**RE:** Villanova University – Lancaster Avenue Housing  
Villanova University – Applicant

Gannett Fleming, Inc. has completed a review of the Villanova University Lancaster Avenue Housing Final Plan for compliance with the Radnor Township Code. This Final Plan was reviewed for conformance with Zoning, Subdivision and Land Development, Stormwater Management, and other applicable codes of the Township of Radnor. A review was also completed for the accompanying plans for the West Lancaster Parking Lot, Pike Field Garage, the Performing Arts Center, and the Church Walk Bridge submitted in support of the Lancaster Avenue Housing Land Development.

**Reference:** Villanova University – Lancaster Avenue Redevelopment  
Final Land Development Review #1 - *Revised*  
Radnor Township, Delaware County, PA

VILLANOVA LANCASTER AVENUE HOUSING  
 BASKETBALL WEEKNIGHT AND WEEKEND EVENTS CIRCULATION PLAN  
 MAY 26, 2015

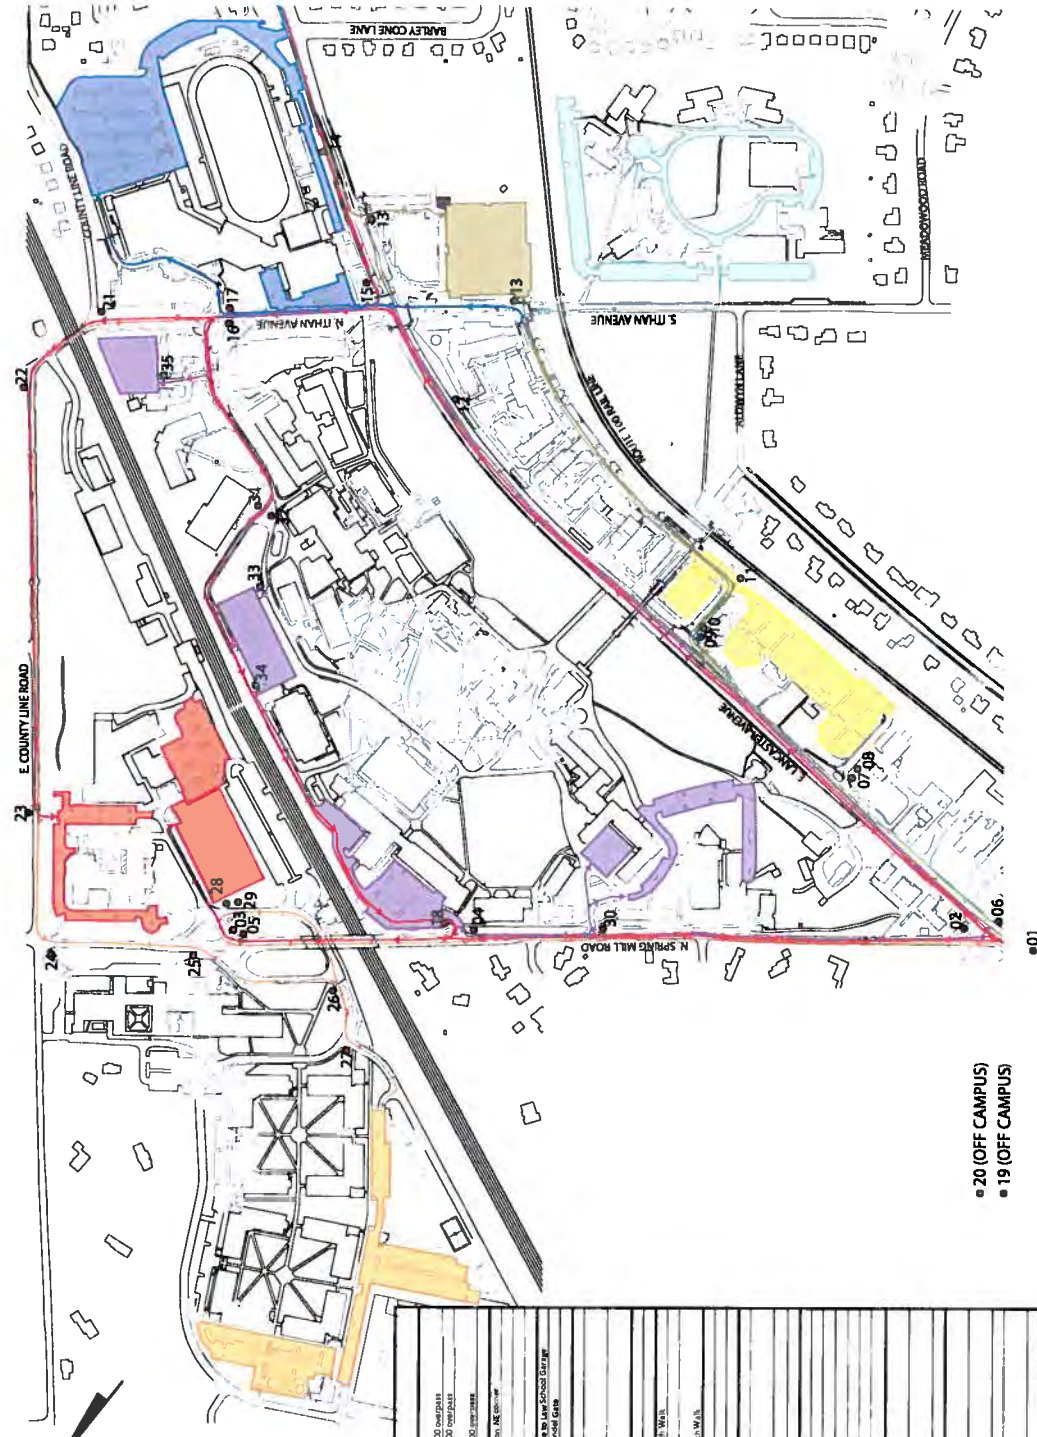
1. The Radnor Police Department should review the Event Traffic Circulation Plan.
2. Refer to the Manual of Uniform Traffic Control Devices (MUTCD) 2009 (Chapter 2L *Changeable Message Signs*) and PennDOT Publication 646 *Intelligent Transportation Systems Design Guide* and verify the DMS sign placement/location based on the reading and decision zone, number of lines, character length and height is adequate for roadway conditions. Although the applicant has indicated the designer will refer to MUTCD 2009; the plans should be reviewed by the Township,

**VILLANOVA LANCASTER AVENUE HOUSING  
PEDESTRIAN PARKING & TRAFFIC PLAN  
PHASE 2B CONSTRUCTION: PIKE GARAGE  
& PEDESTRIAN BRIDGE  
MAY 26, 2015**

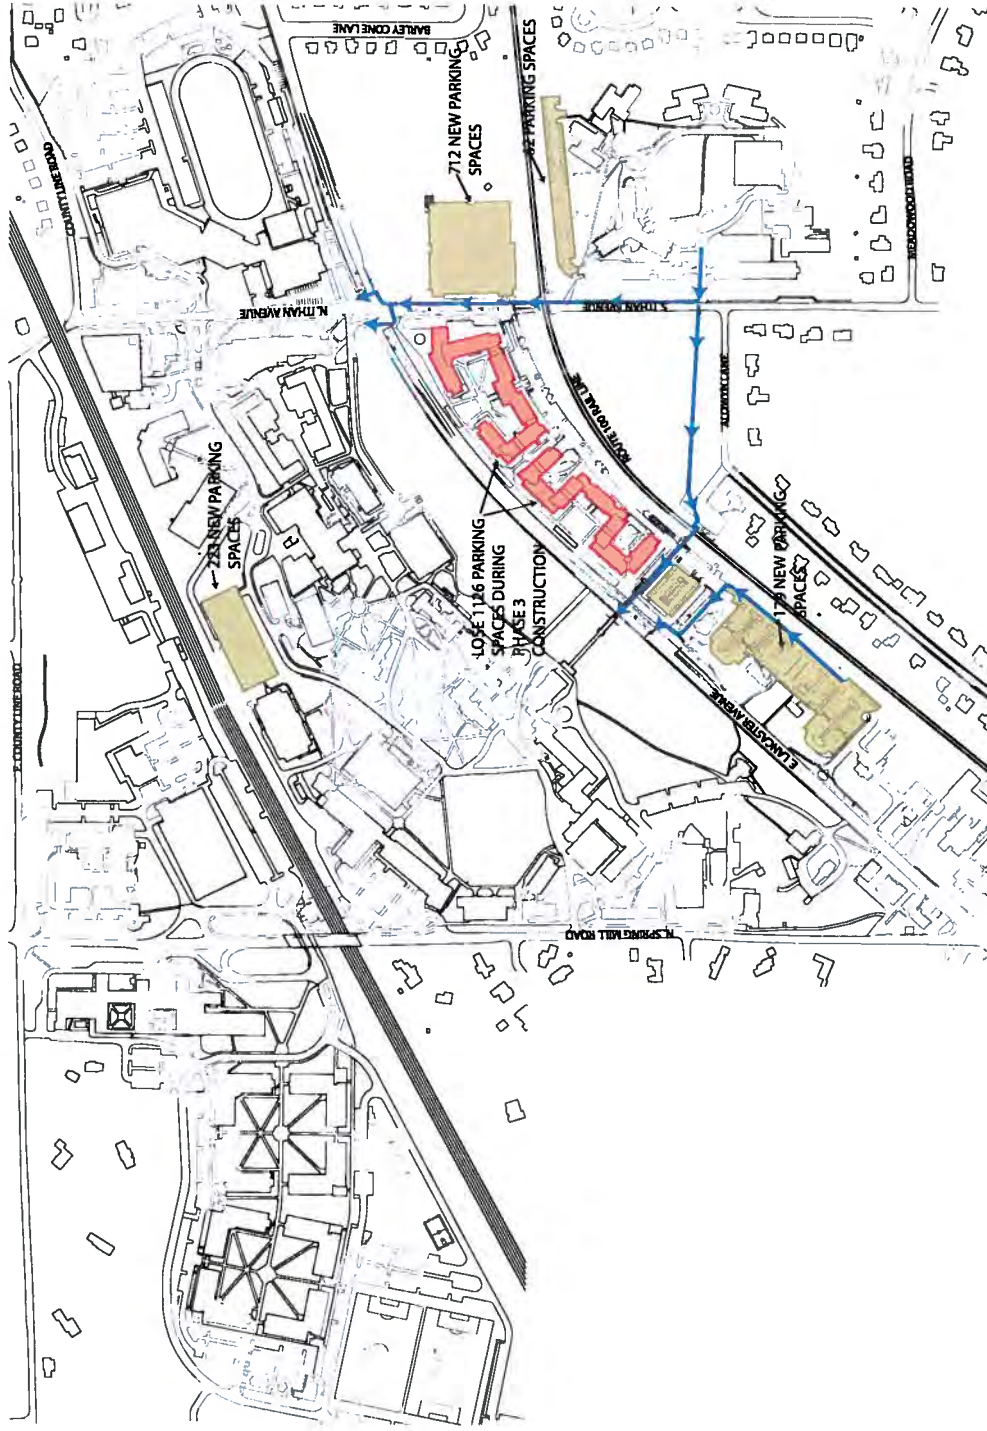
1. Phase 1: Phase 1 improvements may require signal timing modifications at the Church Walk intersection due to the redistribution of traffic from Ithan Avenue to the Church Walk signal. In addition, a Highway Occupancy Permit will be required to eliminate and construct driveway accesses along Lancaster Avenue.
2. Phase 2A: Revise the new temporary walkway to extend to the existing walkway.
3. Phase 2B: The proposed temporary pedestrian route for Phase 2B appears to utilize an unimproved surface along a grassy hill. The pedestrian route surface must be a stable, firm, slip-resistant surface and free of any tripping hazards. Provide additional detail on the Phase 2B pedestrian route in future submissions.
